BOARD OF COMMISSIONERS
Revised AGENDA
Monday, September 24, 2018 - 6:30 PM

Re: **415 Maplewood Avenue**. Preliminary Subdivision Plan, David Semerjian Builders.
#2016-SD-10
Plans by Edward B. Walsh Associates, sheets 1-16, dated 12/08/2014, last revised 04/11/2018.
Ninety Day Review Period: October 3, 2016, extended indefinitely

DEVELOPMENT PLAN
FOR
DAVID SEMERJIAN BUILDERS
415 MAPLEWOOD AVENUE
RADNOR TOWNSHIP DELAWARE COUNTY, PA.

PRELIMINARY
POST CONSTRUCTION
STORMWATER MANAGEMENT
DETAILS

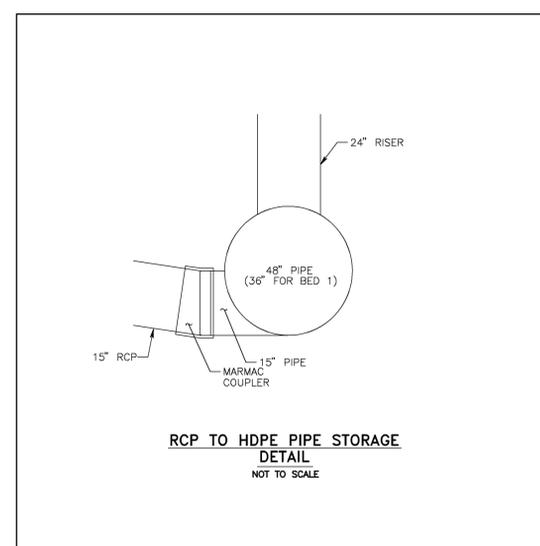
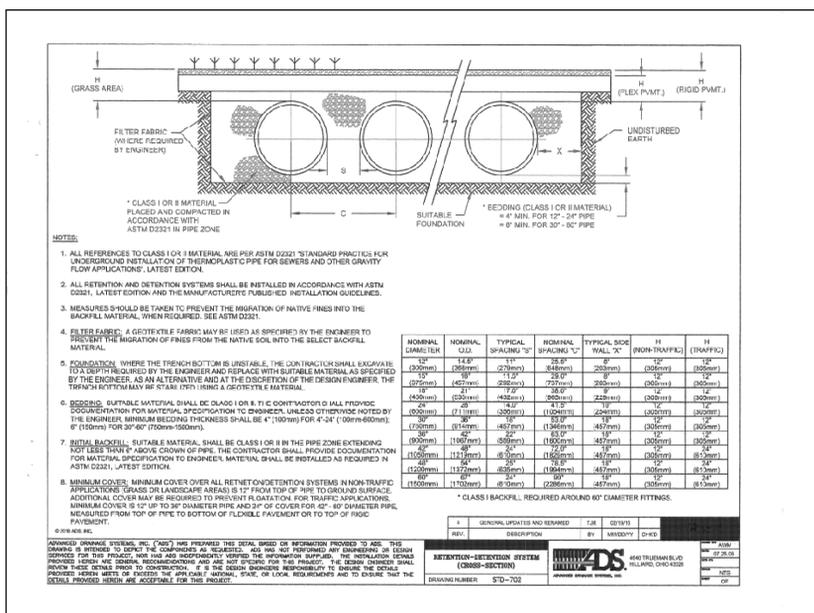
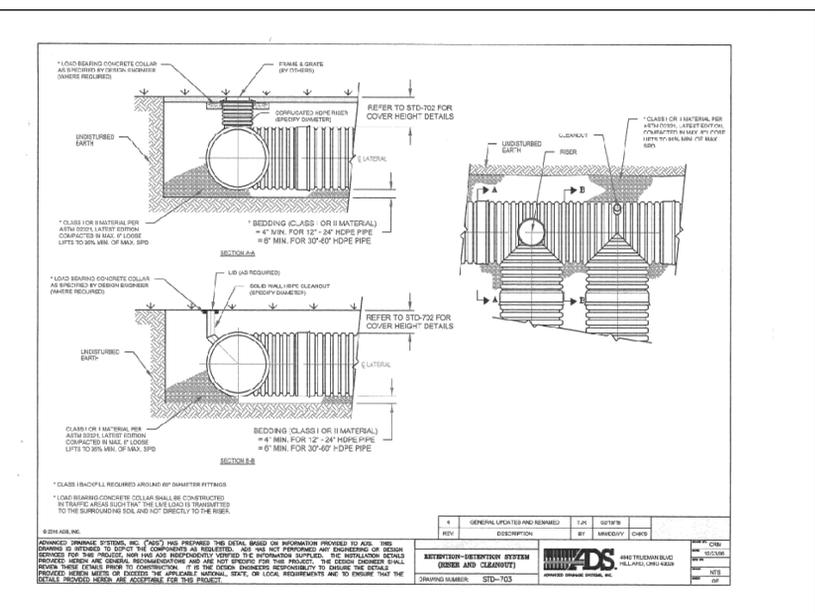
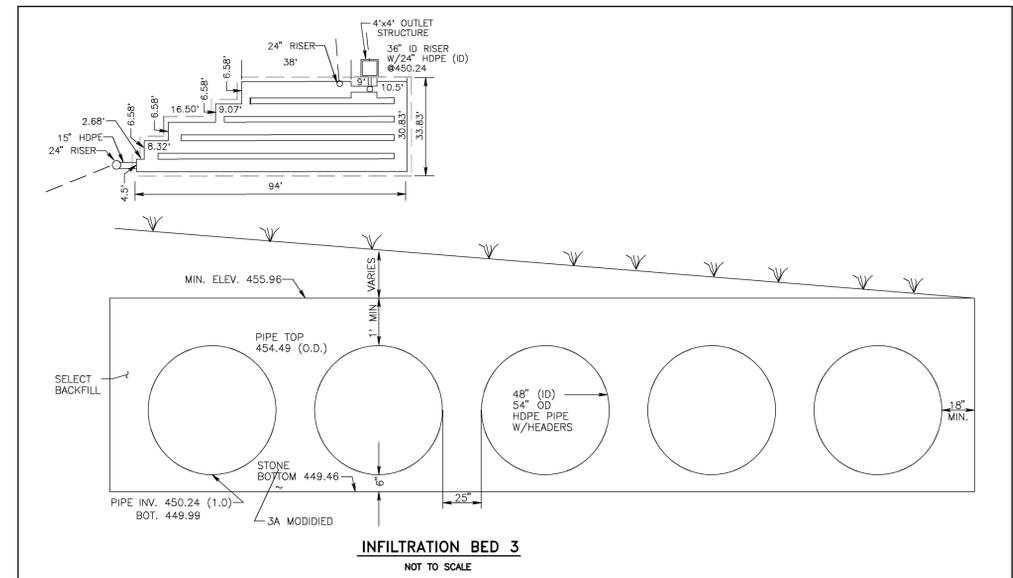
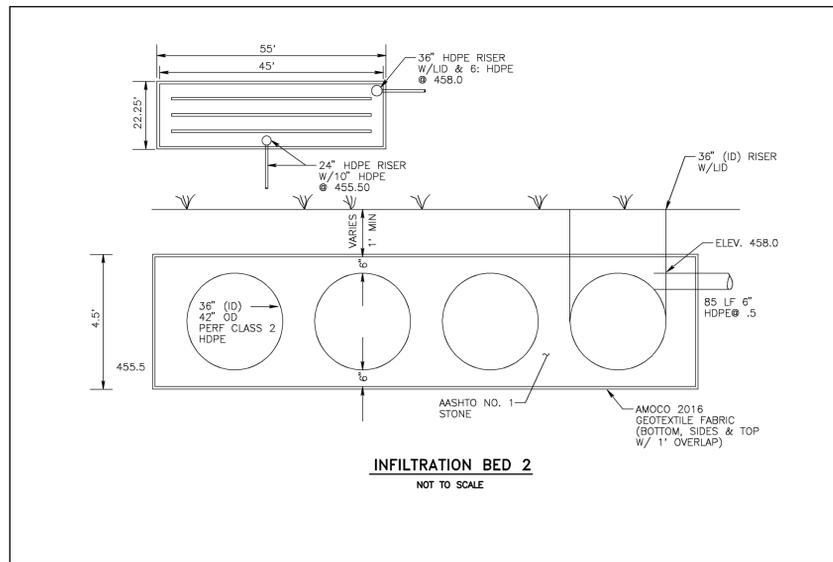
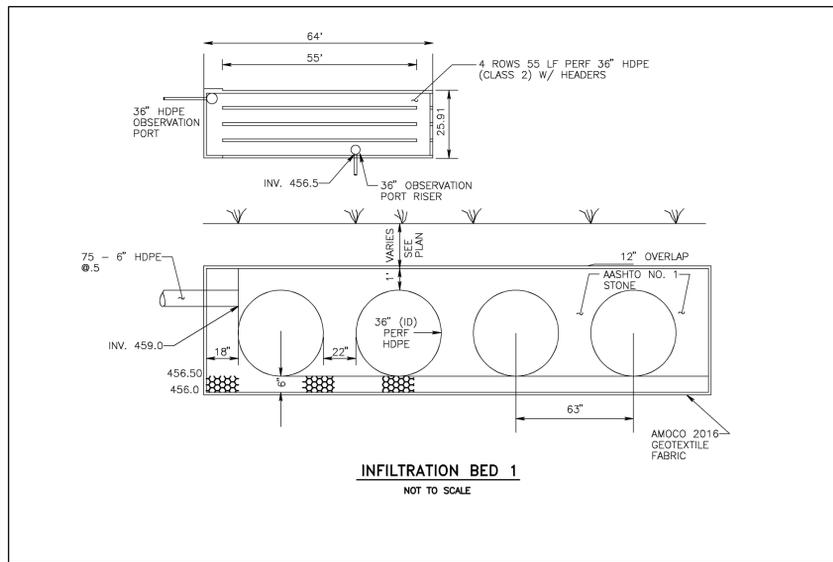
3. The Bed #3 Outlet Structure Detail on Sheet 10 and the orifice structures listed in the hydrograph (page 35) are not consistent. This inconsistency must be revised.

3. The applicant must show the water line crossings on the stormwater profiles on Sheet 10, specifically between Inlets #3 and #4, Inlets #1 and #2, and between Bed #3 and the level spreader.

PRELIMINARY LANDSCAPE PLAN

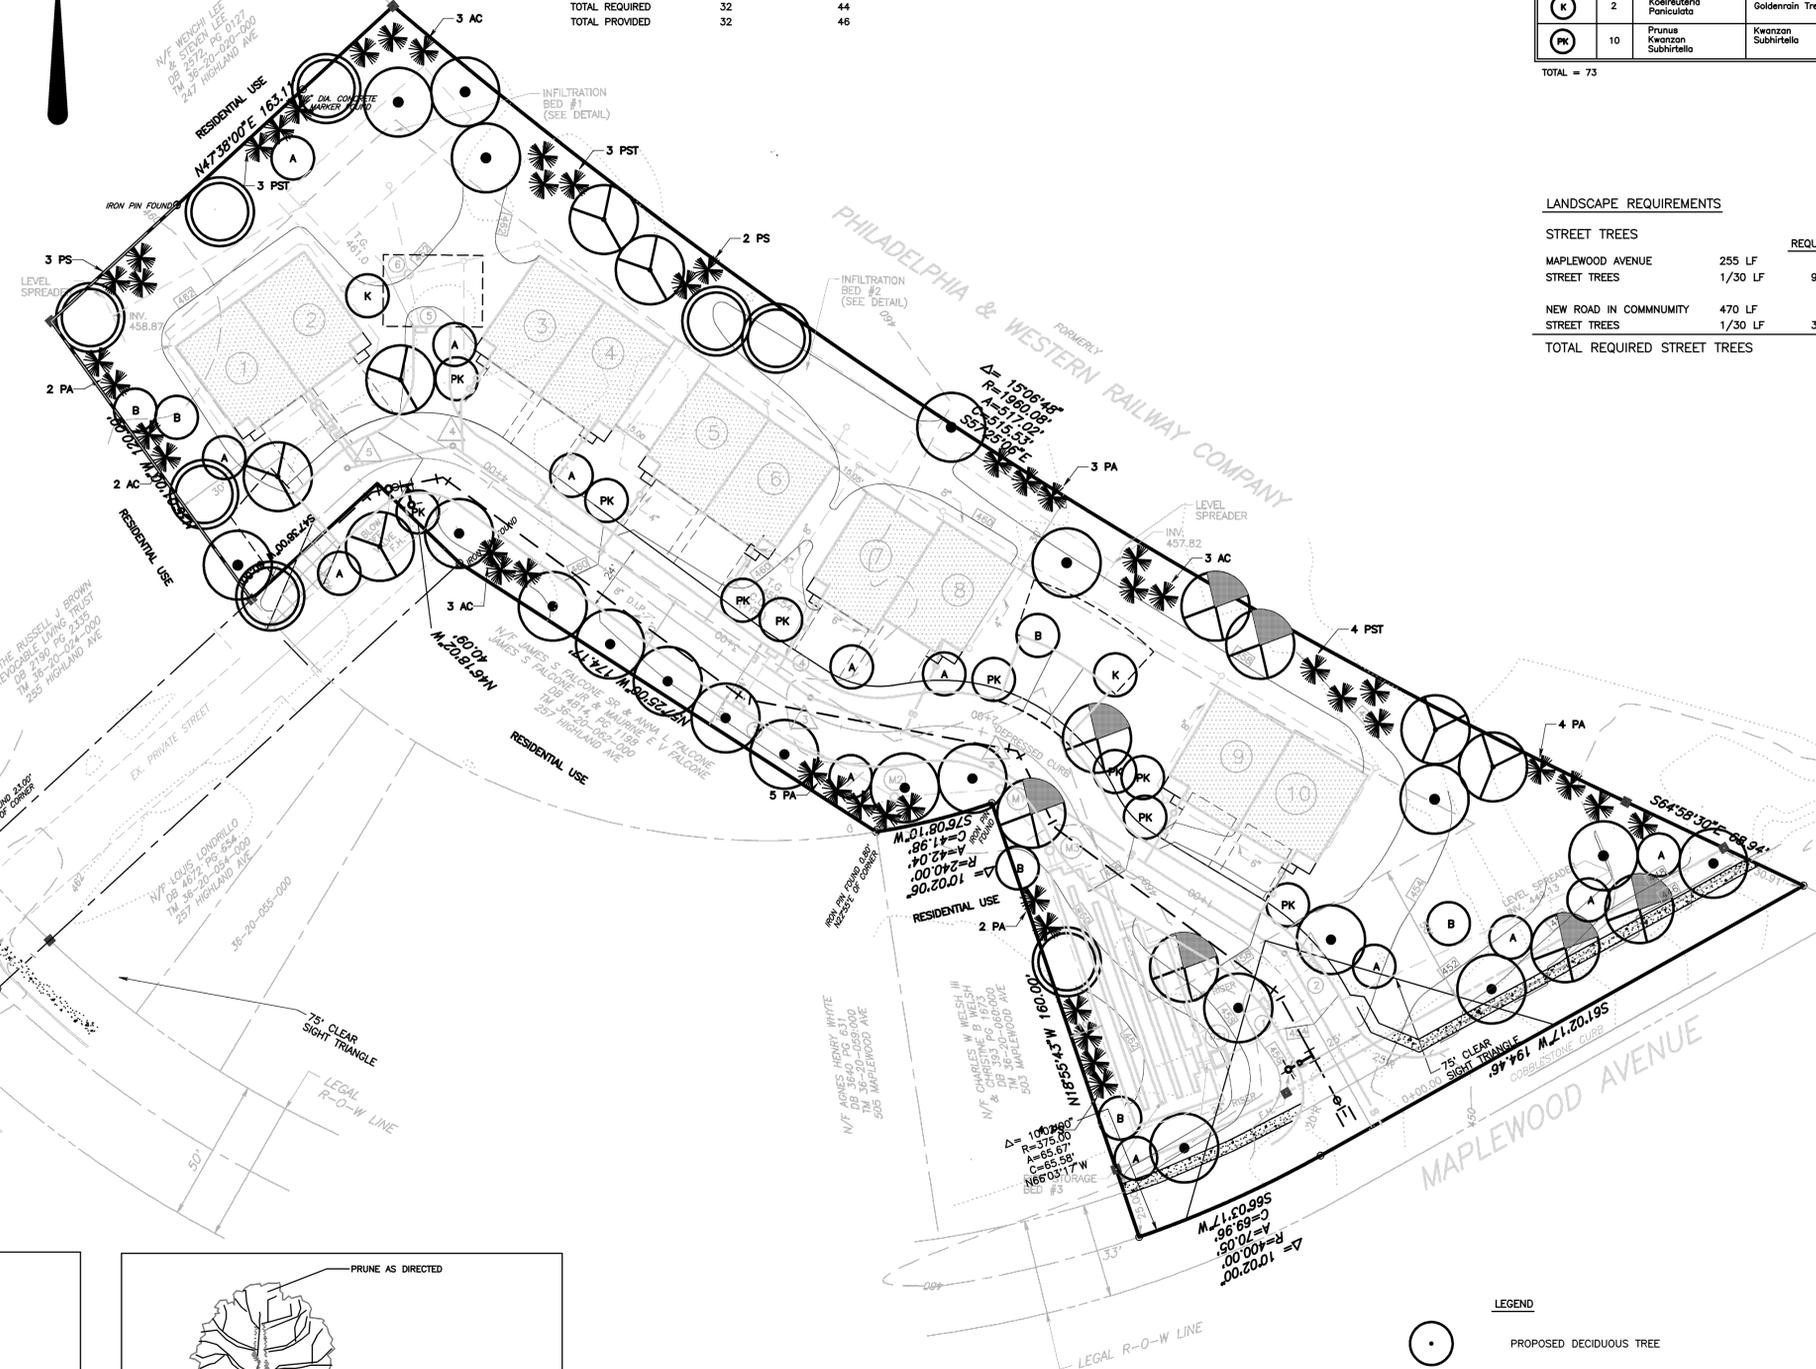
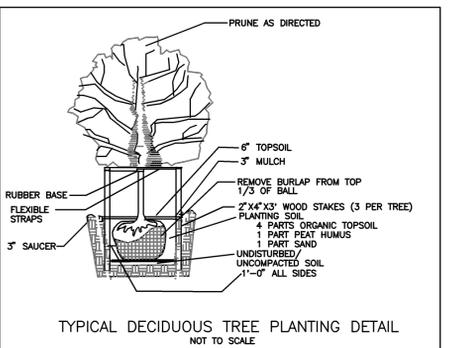
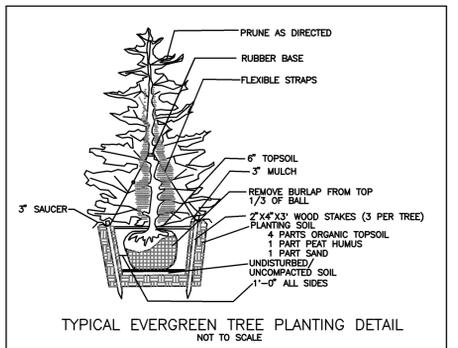
7. §255-38 – Sheet 12 of 18 indicates that there will be plantings located in the existing private street and interfering with the proposed 12' emergency access. This must be revised.

8. §255-38.H – All street trees provided on the plans must be in accordance with this section. There are trees listed on sheet 12 of the plans that are not listed in this section. This must be revised or a waiver requested. The applicant has indicated that due to the changes of the plan, they are required to go back to shade tree.

7. §255-38 – Sheet 12 of 18 indicates that there will be plantings located in the existing private street and interfering with the proposed 12' emergency access. This must be revised.

8. §255-38.H – All street trees provided on the plans must be in accordance with this section. There are trees listed on sheet 12 of the plans that are not listed in this section. This must be revised or a waiver requested. The applicant has provided street trees and buffer trees. The last plan submission indicated that 53 replacement trees were provided, but have been removed from this submission. An explanation must be provided to why the 53 replacement trees are no longer being provided.

8. §255-38.H – All street trees provided on the plans must be in accordance with this section. There are trees listed on sheet 12 of the plans that are not listed in this section. This must be revised or a waiver requested. Additionally, the number of trees provided must clearly be indicated. There are 51 Street Trees, 17 Canopy Trees and 24 Evergreen Trees required according to code. The plan also indicates that there are 53 total replacement trees. The total number of plans provided in the evergreen and deciduous planting schedules is 100 total trees. An explanation must be provided.
